PROFILE ALIGNMENT AND GRADE OF P.C.4288
SANITARY SEWERS PAGE 1
TO BE CONSTRUCTED IN DOUBLE SCALE
CRENSHAW BLVD.
AND
TRACT N° 23398 (25,562)
PRIVATE CONTRACT NO. 4288
W.S. 27
7 SHEETS; 11 PAGES
SCALE: HORIZ. 1"=40' VERT. 1"=4' JANUARY, 1957
PREPARED BY THE OFFICES OF
ENGINEERING SERVICE CORPORATION
By *[Signature]* REG. C. E. NO. 2092
FOR LEGEND SEE PLAN NO. S-A-64

P.C. 4288

25569

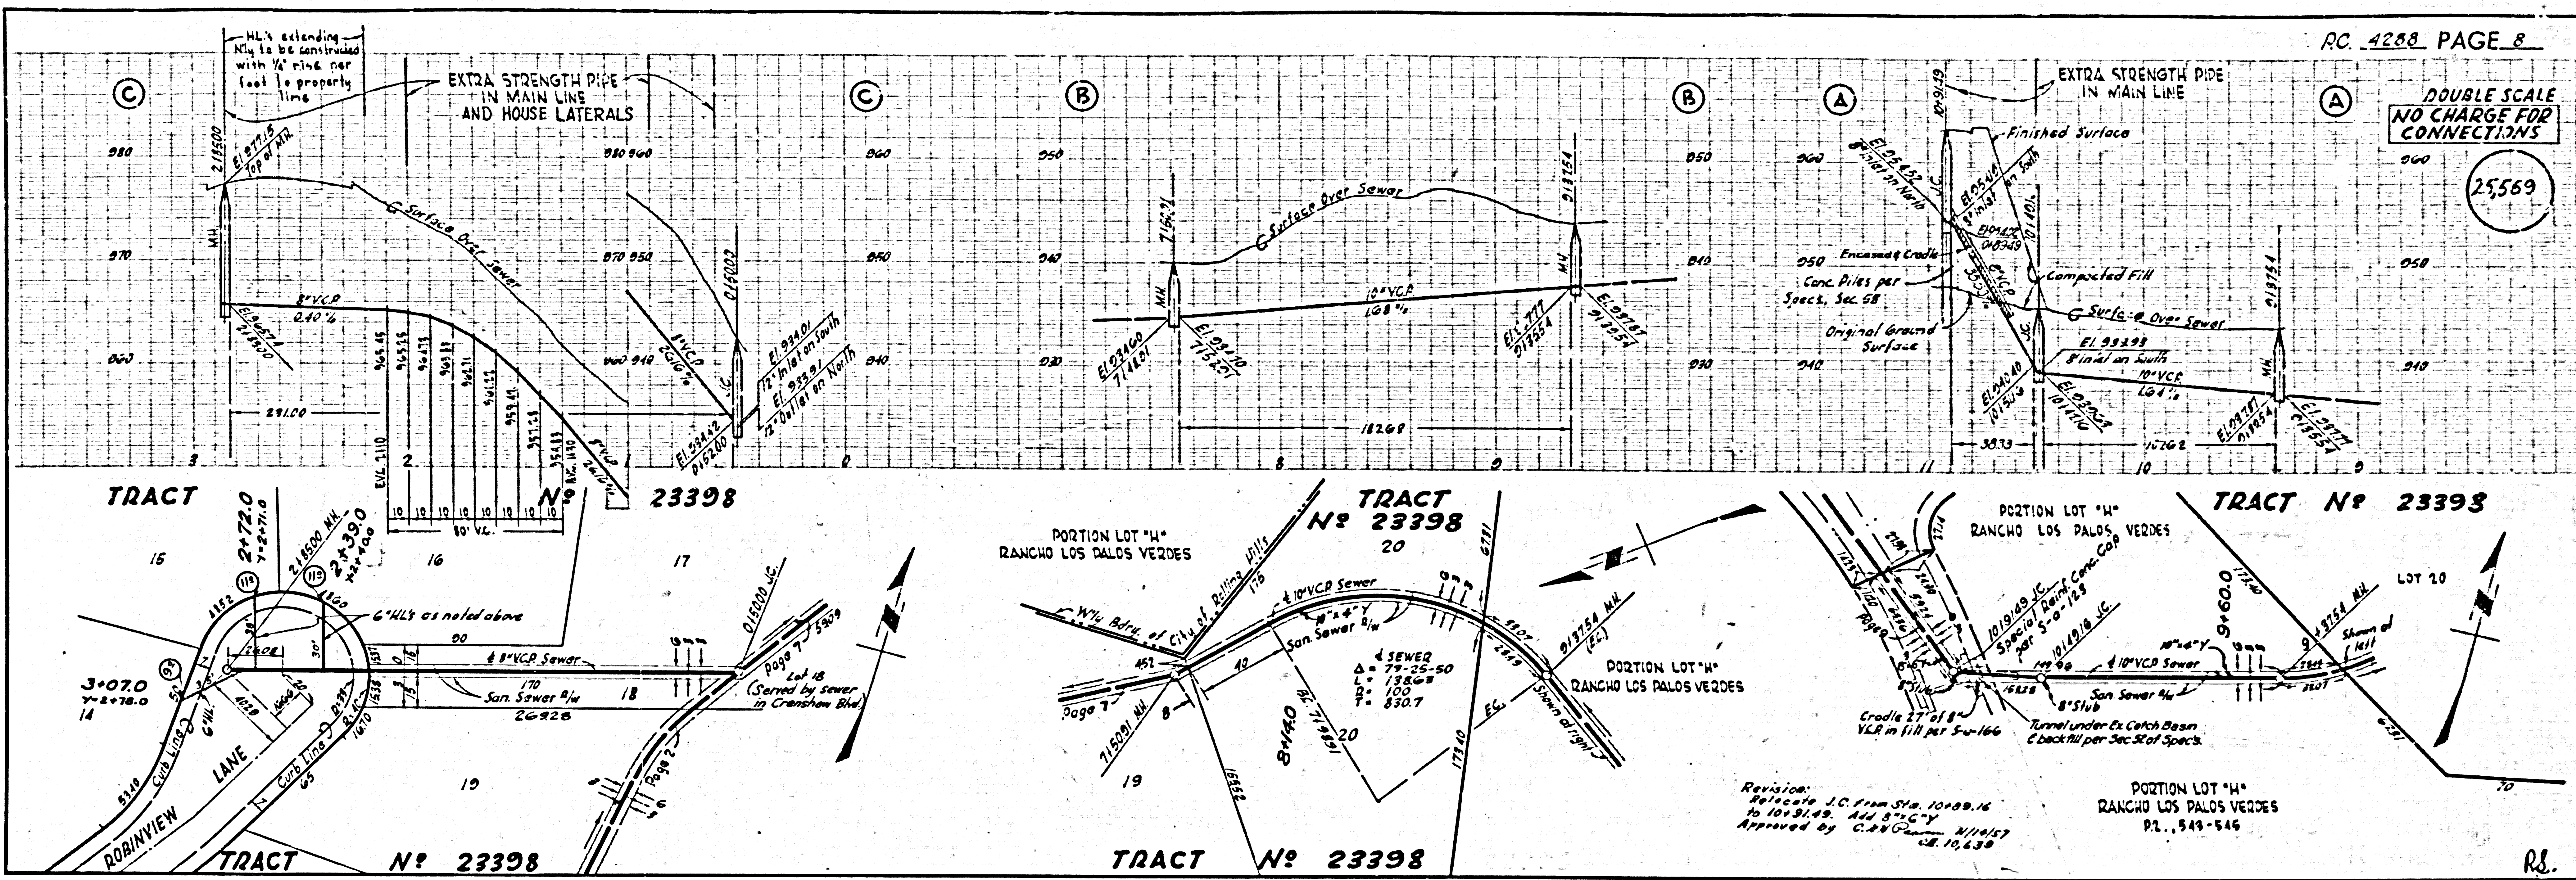
Revision:
Relocate I.C. from Sta. 10+89.16
to 10+91.49. Add 8" V.C.P.
Approved by C.E.V. 1/11/57
12.10.63

SPECIAL REINFORCED CONCRETE SUPPORT FOR STANDARD SEWER MANHOLES

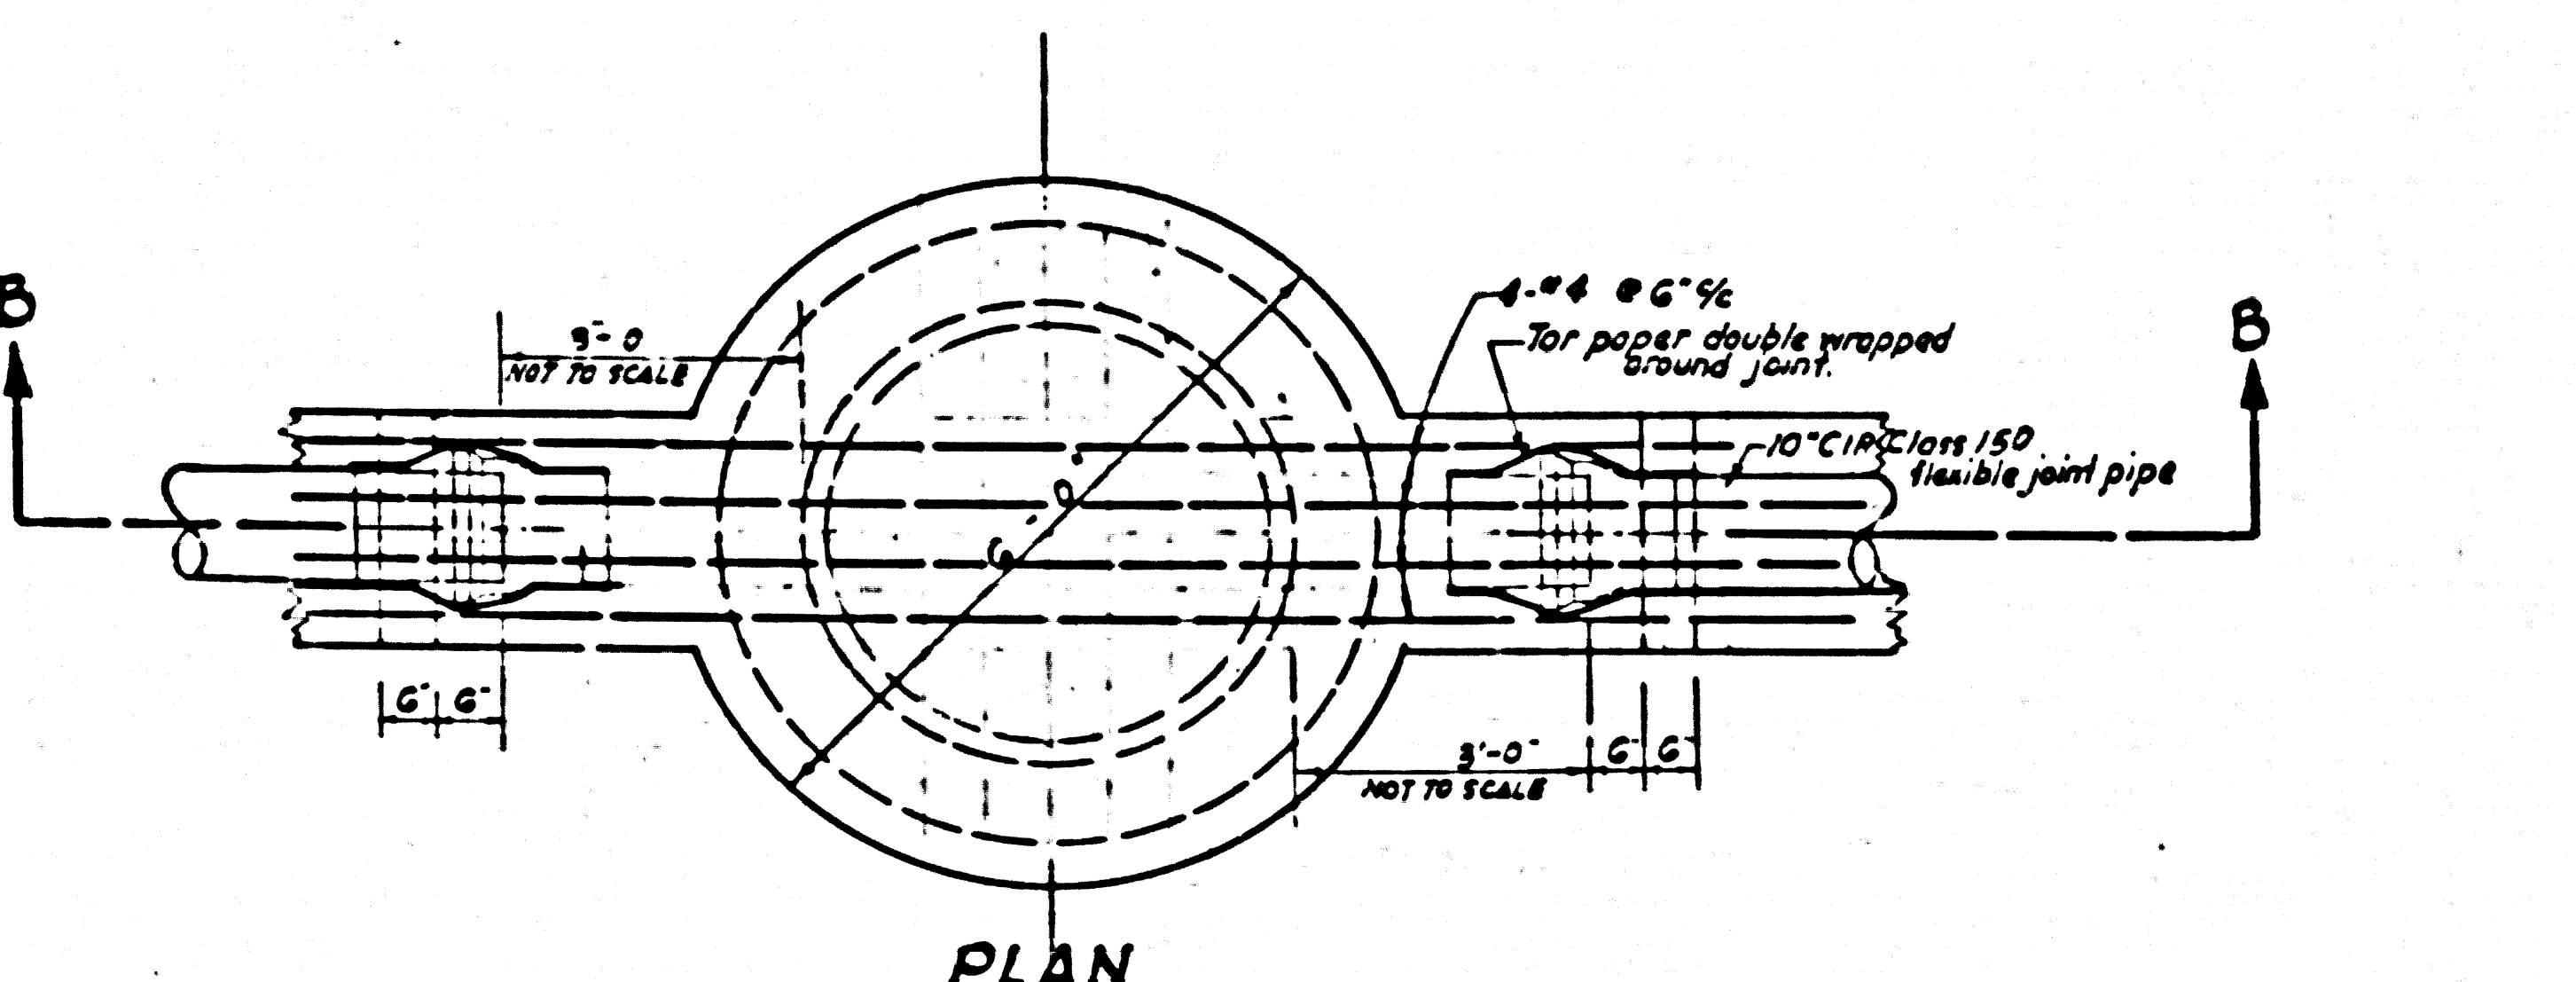
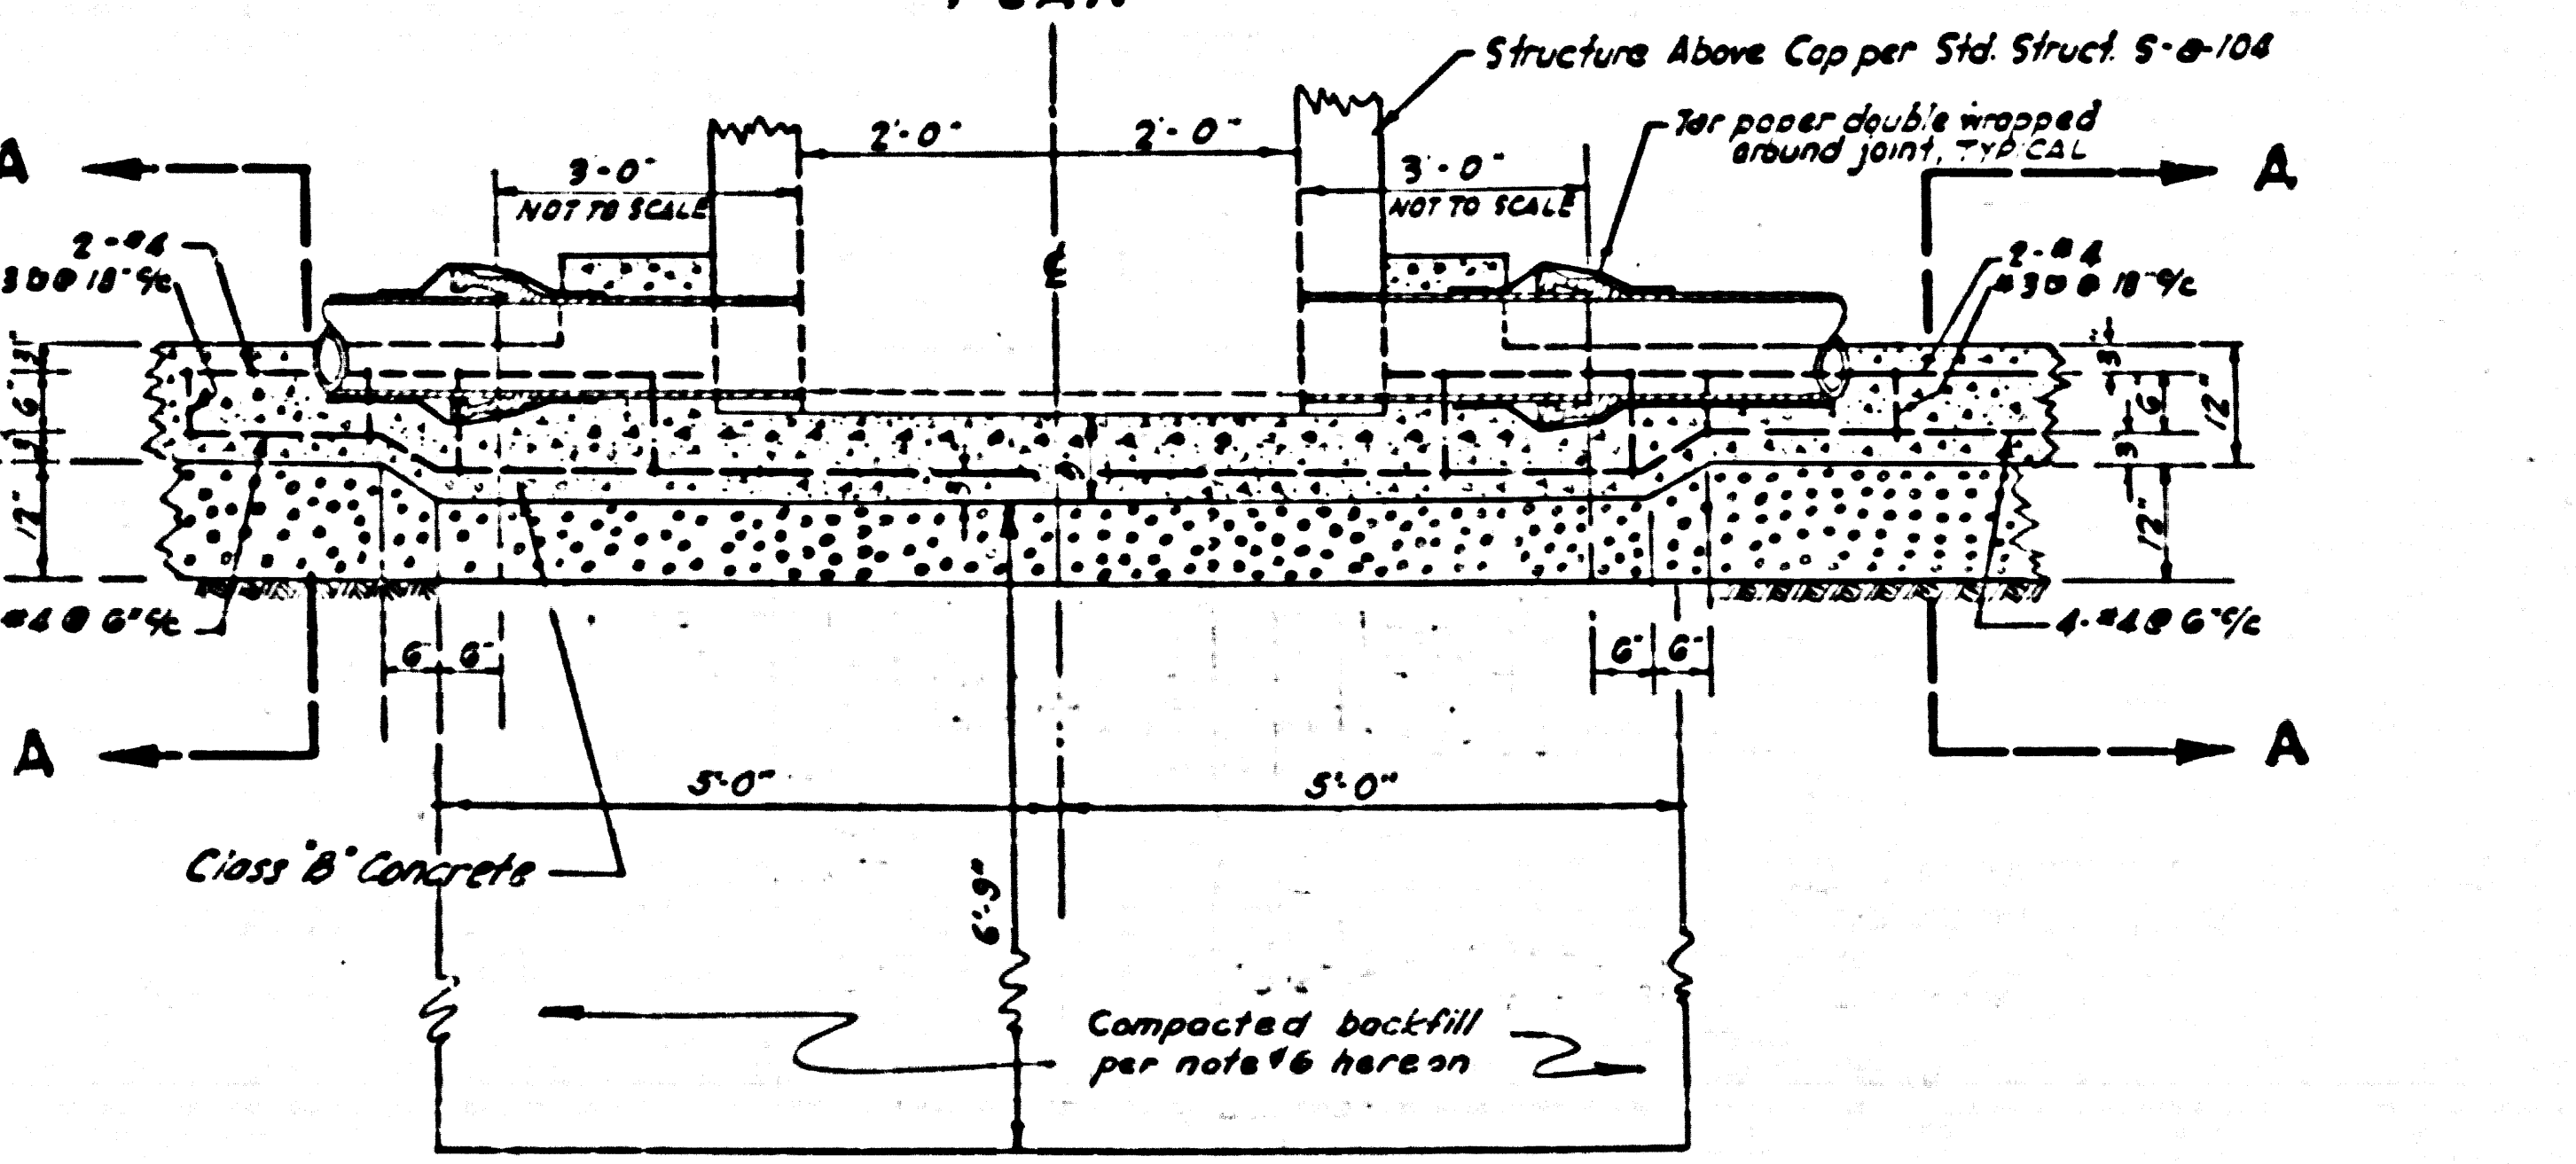
Revision:
Delete pipe supports for M.H. and substitute M.H. foundation of compacted backfill.
APPROVED BY: *Chas. J. Pinner* 11/3/67
OFFICE OF COUNTY ENGINEER CR 4639

- 6- Foundations for all M.H.s. within Cranshaw Blvd. shall consist of the excavation of a hole approx. 10' sq. ft. 6'-9" below bottom of M.H. slab. This hole shall be backfilled & compacted to a relative density greater than 90%. The compaction shall be done under the supervision of a Soil Engineer.
